### 49 CFR Part 571

### Federal Motor Vehicle Safety Standards; Door Locks and Door Retention Components

**ACTION:** Final rule; response to petitions for reconsideration; technical amendments.

**FIGURE 7 • VEHICLE COORDINATE REFERENCE SYSTEM FOR INERTIAL TESTING**

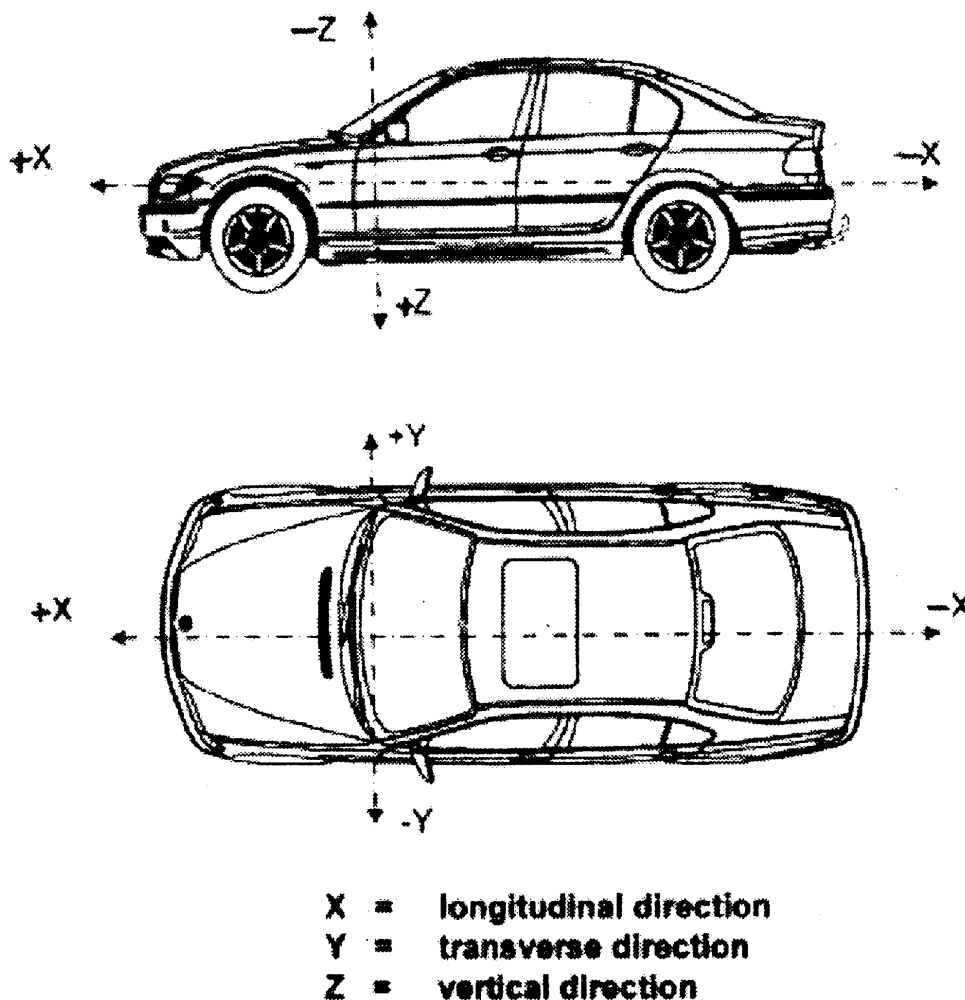
##### *b. Technical Amendment to Figure 7*

Prior to the February 2007 final rule, FMVSS No. 206 did not have a figure that graphically displayed the vehicle coordinate reference system to be used for inertial testing. The GTR provided such a figure because part of the GTR referenced various directions with respect to different vehicle axes. The NPRM proposed, and the February 2007 final rule adopted, this same GTR figure as Figure 7.

Although the agency did not receive any comment regarding Figure 7 in response to both the NPRM and the February 2007 final rule, after publication of the final rule NHTSA realized that x-axis and the z-axis in Figure 7 were not consistent with SAE J211 (Instrumentation for Impact Test) or with the sign conventions used in other Federal motor vehicle safety standards such as FMVSS No. 208 and FMVSS No. 214. Therefore, NHTSA is making a technical amendment to FMVSS No. 206 by modifying Figure 7 to be consistent with SAE J211 and the sign convention for other Federal motor vehicle safety standards as follows:
